APPLICATION NO.	FILING DATE	FIRST NAMED INVENTOR	ATTORNEY DOCKET NO.	CONFIRMATION NO.
10/734,442	12/12/2003	Helmut Steinhilber	074623.0111	9668
7590	11/21/2006		EXAMINER [REDACTED]	JOERGER, KAITLIN S
Andreas Grubert Baker Botts L.L.P. One Shell Plaza 910 Louisiana Houston, TX 77002-4995			ART UNIT [REDACTED]	PAPER NUMBER 3653

Office Action Summary	Application No.	Applicant(s)	
	10/734,442	STEINHILBER ET AL.	
	Examiner	Art Unit	
	Kaitlin S. Joerger	3653

DETAILED ACTION

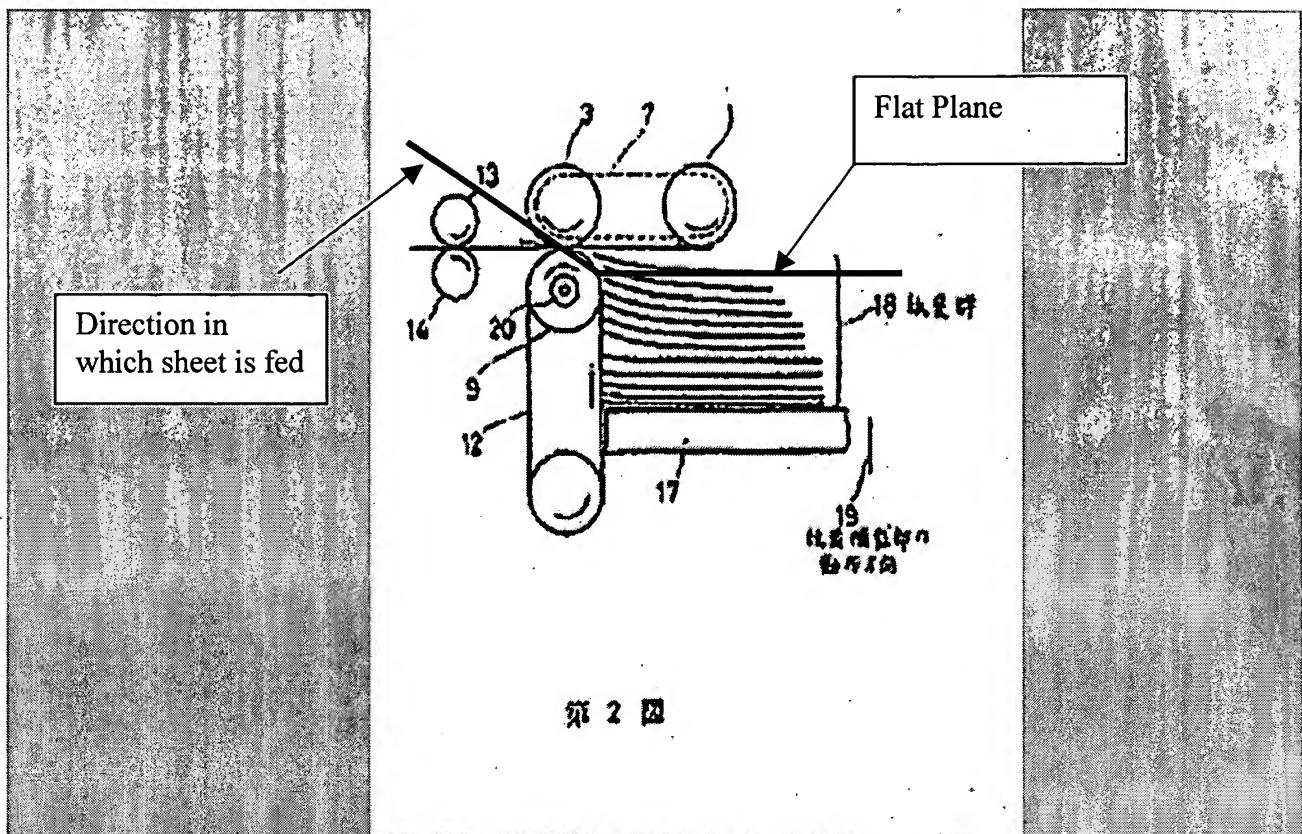
- a rolling action device, 1, that lies on the uppermost sheet of the pile and exerts a rolling action on the uppermost sheet in a feeding direction, see figure 2;
- a stop, 12, mounted before the front edge of the pile pointing in the feeding direction, the front edge of the sheet is moved against the stop and wherein the stop can be moved upwards at an angle of more than 90 degrees to the flat plane and direction in which the sheet is fed, see figure 2 reproduced below:

As is clearly shown in the picture, the angle between the flat plane and the direction in which the sheet is feed in clearly more than 90 degrees.

Applicant's arguments filed 13 September 2006 have been fully considered but they are not persuasive. The applicant argues that the JP '237 reference does not teach the feature of a stop that is moved at an angle of more than 90 degrees in relation to a flat plane and a direction in which the sheet is being feed. It is clear from the figures shown above that as the stop, belt 12, moves up and over the top roller 9 it moves up an angle that is greater than 90 degrees to a flat plane, where the flat plane is the plane of the stack of sheets. Therefore, the JP '237 does in fact teach all the feature of the claimed inventions and claims 1-3, 5-10, and 14-17 remain rejected.
